Department of Transportation and Public Works  
Office of the Director  
701 NW 1st Court • 17<sup>th</sup> Floor  
Miami, Florida 33136

March 28, 2023

**RE: Ocean Drive Temporary Pedestrian Plaza (Application No. 2022001803)**

Exhibit 1

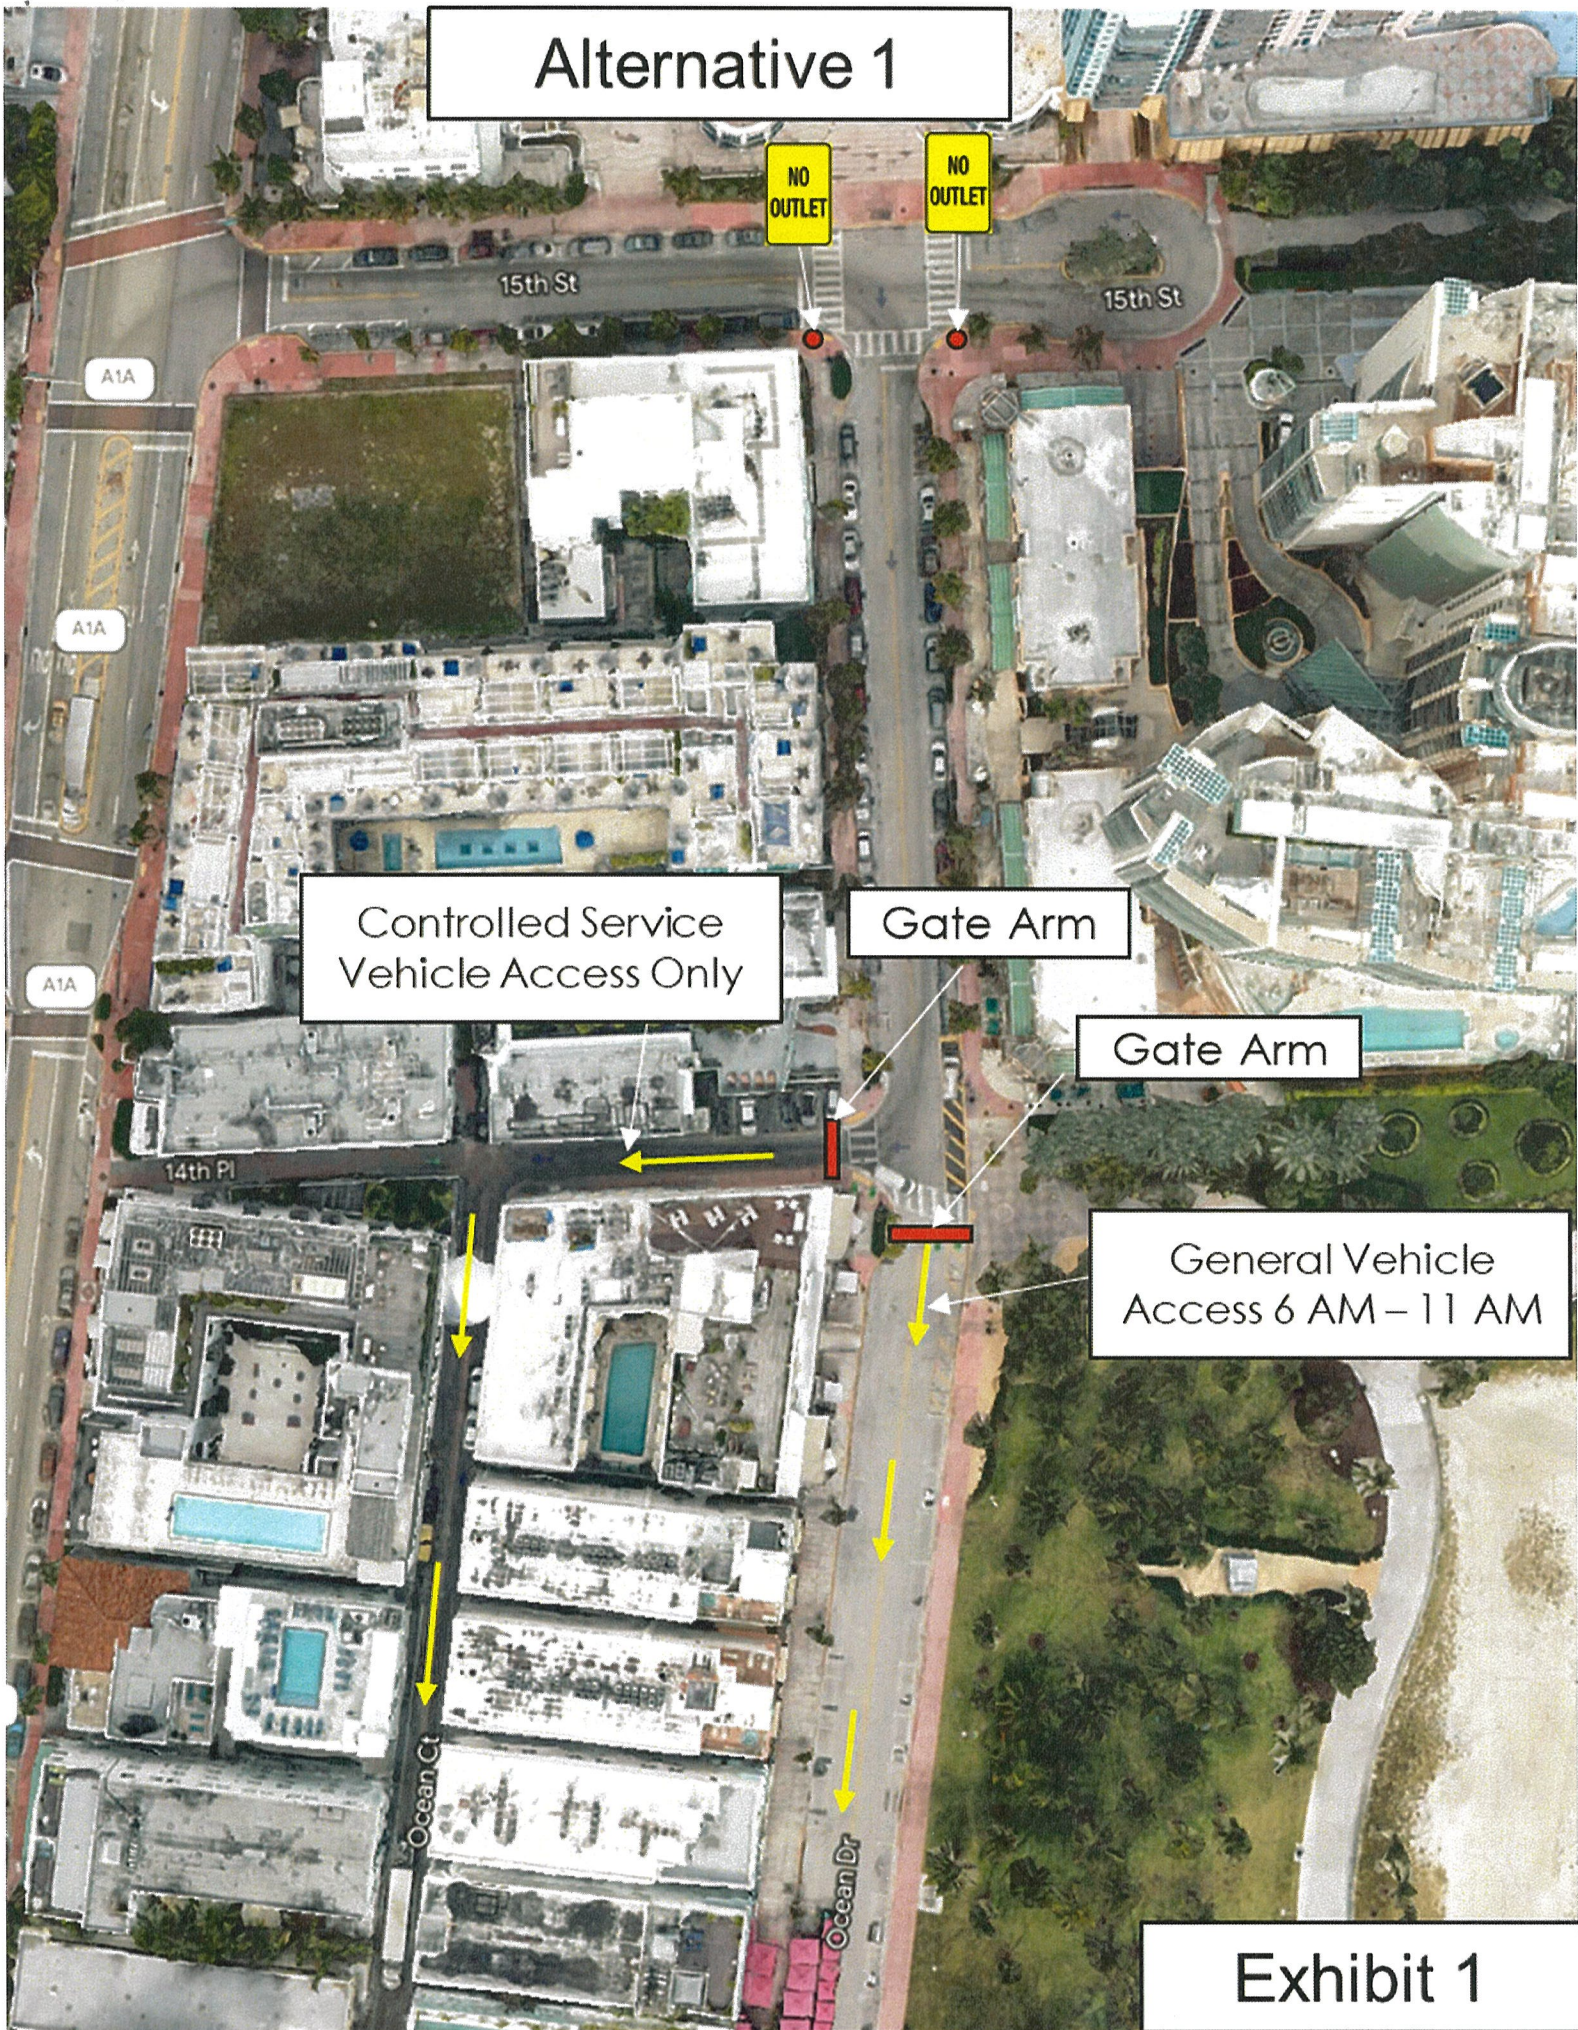
Since the receipt of your letter, DTPW staff has performed field reviews and conducted working sessions to understand the technical and safety implications of your proposal. Upon review we remain concerned that the proposed solution fails to address safety issues associated with high south-bound traffic volumes along the Ocean Ct. alleyway as a result of limited vehicular access to Ocean Drive.

- Alternative 1: Gate closure at 14<sup>th</sup> Place and Ocean Drive with controlled access for service vehicles. See Exhibit 1.
- Alternative 2: Reconfiguration of the alleyway for northbound service vehicles traffic only. See attached Exhibit 2.

Both alternatives address DTPW's primary safety objective of limiting general traffic along the Ocean Ct. alleyway. Under these scenarios, A1A would serve as the alternate route for vehicular traffic. T-turnarounds would be required at the 13<sup>th</sup> and 14<sup>th</sup> Street alleyway intersections. As a result, traffic entering the intersecting streets will have an adequate method of egress and the Ocean Ct. alleyway would revert to its originally intended use for service vehicles only.

Miami Dade County considers both alternatives viable and would recommend a 90-day pilot project implementation. Prior to commencement of the pilot, the City of Miami Beach must schedule a meeting with members of DTPW to jointly develop a methodology for analysis of the pilot. The methodology must include but is not limited to data collection strategy, documenting loading conditions, access management, passenger drop-off, public input, education, and compliance. The methodology must also identify the intended outcome and measures of success. The pilot project would require monthly reviews of impacts to traffic, safety concerns, and unforeseen conflicts. A detailed daily log shall be required and should be maintained by the City throughout the pilot project implementation, the log will provide specific traffic monitoring measures which will be identified and accepted by both the City and the County traffic engineering teams in advance of implementation. City staff will conduct observations and obtain feedback from affected residents, businesses, customers, and workforce with regard to the pilot. Upon completion of the pilot, the City must submit a signed and sealed report documenting the results, determining success, and providing recommendation for next steps. The outcomes of the pilot will be utilized to determine whether the permanent implementation of traffic modifications is feasible or if further adjustments are required.
